Dresden Station

**TABULAR SUMMARY OF PROPOSED CHANGES TO SITE
EMERGENCY PLAN**

Attachment 2
TABULAR SUMMARY OF CHANGES TO DRESDEN EMERGENCY PLAN

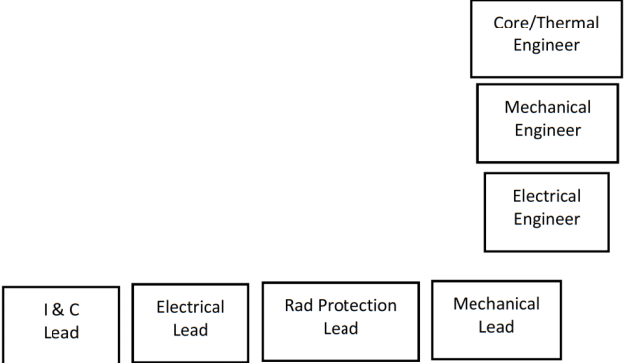
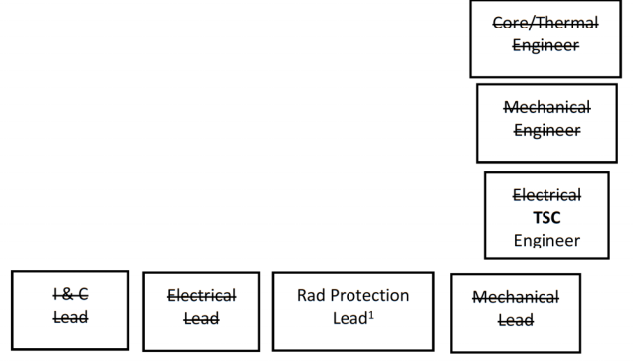
EP-DR-1000 Part II Section B.5.a.9 OSC Leads OSC	9) <u>OSC Leads</u> OSC OSC Leads report to the OSC Director and are assigned from the following station departments: <ul style="list-style-type: none"> • Mechanical Maintenance • Electrical Maintenance • Instrument and Control 	9) <u>OSC RP Leads</u> OSC OSC Leads and report to the OSC Director and are assigned from the following station departments: <ul style="list-style-type: none"> • Mechanical Maintenance • Electrical Maintenance • Instrument and Control 	Evaluation of these ERO position's responsibilities are performed in Attachment 4, ERO Task Analysis, including an evaluation of which responsibilities can be deleted and which can be reassigned.
